To: Historic Landmark Commission Members
From: Joel Paterson, AICP 
Date: December 29, 2009
Re: PLNHLC2009-01224 – Steven's Garage at 58 South 1200 East

HISTORICAL LANDMARK COMMISSION STAFF REPORT

Stevens Garage New Construction 58 South 1200 East PLNHLC2009-01224 December 2, 2009

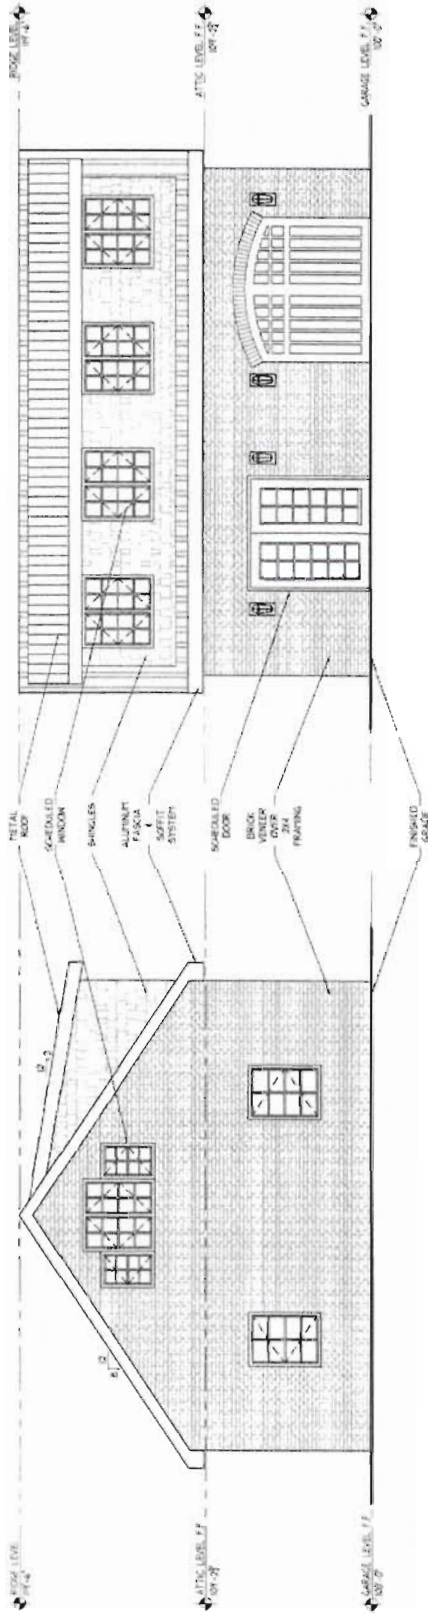
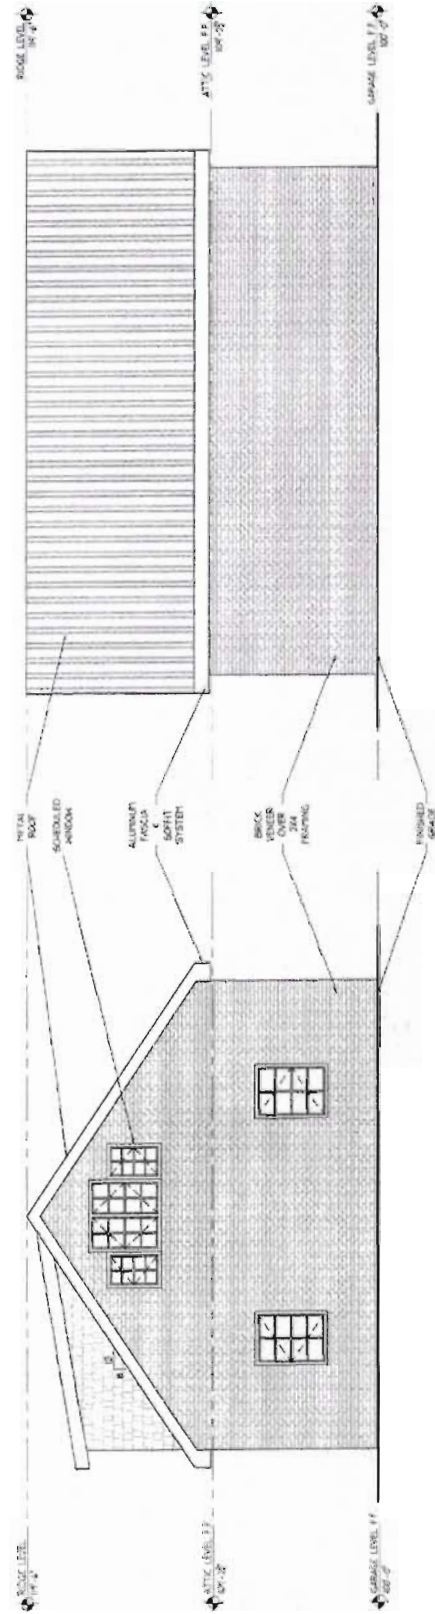
Finding: The proposed accessory structure is different in architectural style, orientation of the roof, height, and material from the principal structure and from the majority of the accessory structures in the block. The proportion and height of the proposed structure is not subordinate to the primary building. The proposed accessory structure does not fit this standard.

Analysis: The proposed accessory structure proposes to use materials that are different from the materials used on the principal structure and in the neighborhood. The use of metal shingle roof is not common in the surrounding structures and streetscape.

Finding: The materials proposed on accessory structure are not visually compatible with those utilized in the primary building or materials found in the neighborhood. The project does not meet the intent of this standard.

The location of the garage at the rear of the lot is in keeping with the character of the block and historic district. However, because of its bulk, height, and orientation of the roof, the proposed structure competes and disrupts the visual rhythm of the primary façade of the house as well as the neighborhood.

Finding: The overall impact of the proposed accessory structure on the streetscape would be substantial. The proposed project does not meet the intent of this standard.

See attached redline PDF sheet A002.

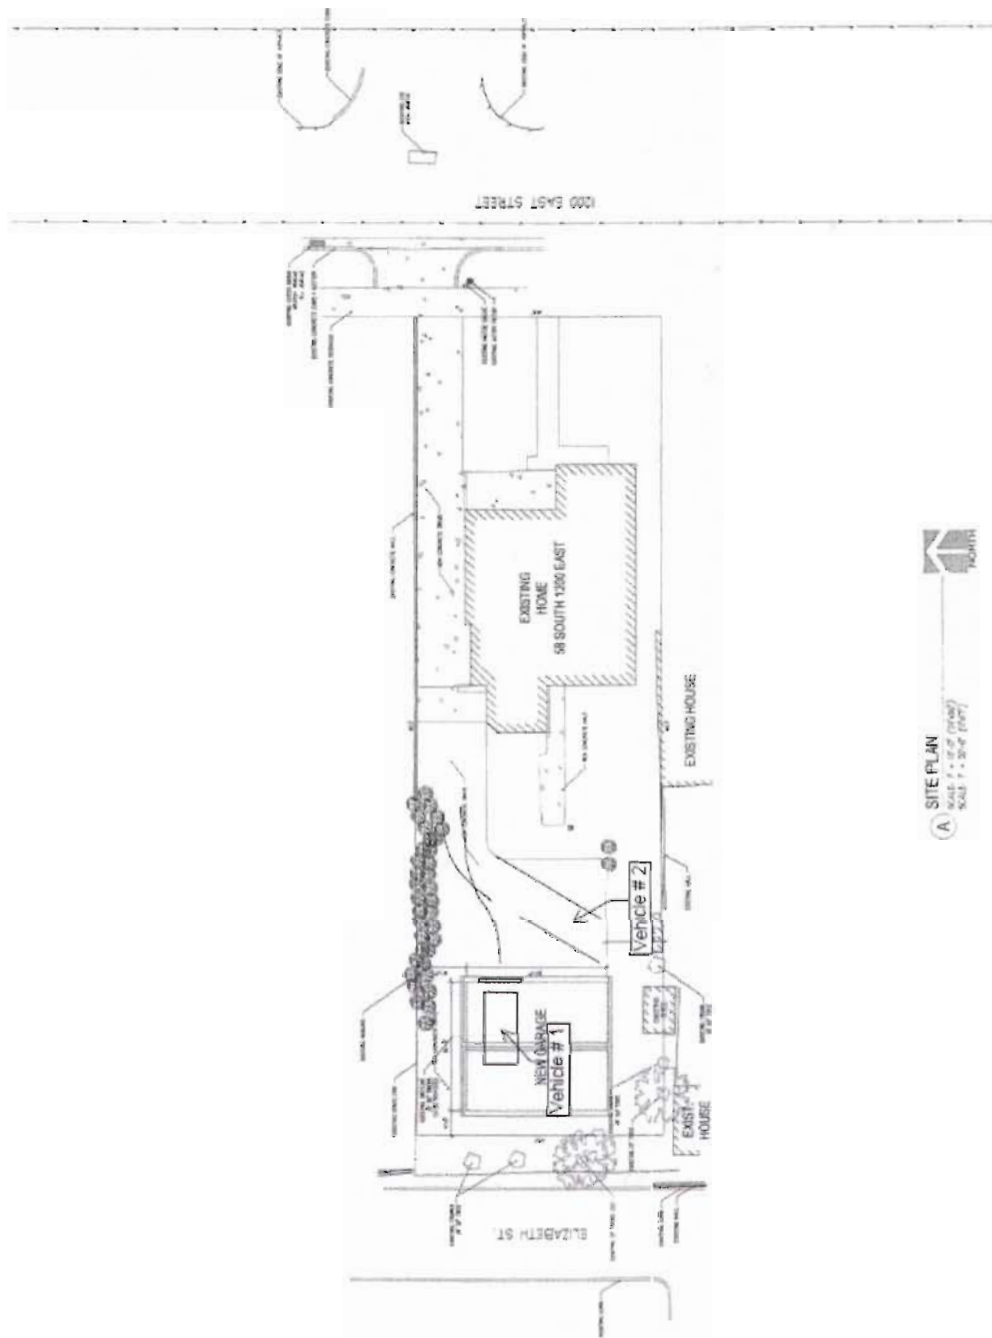
The proposed garage is shown for only one parking stall. The second required parking stall (two stalls per single family residence)can be accommodated in front of the building to the south.
